Sep. 12th, 2022

METFB-40-BM Change Notification

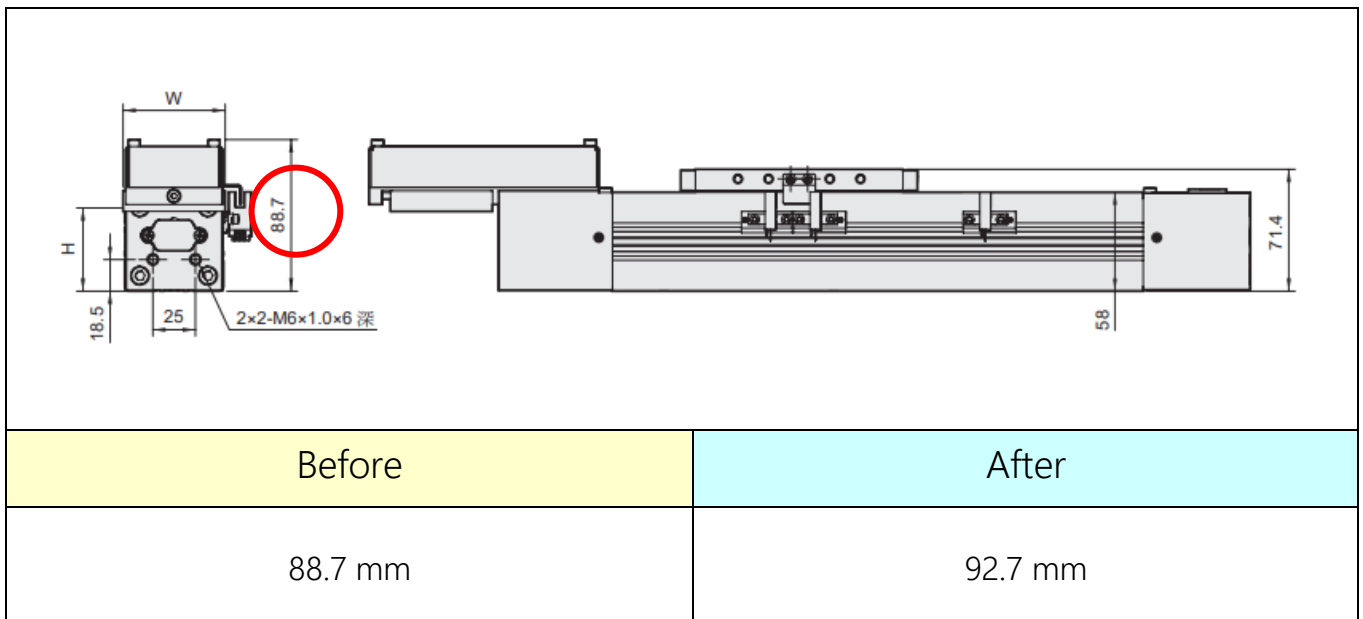
1. Model series
METFB-40-BM (Motor mounted position: down)
2. Design change reason
Optimize the internal structure design.
3. Change descriptions
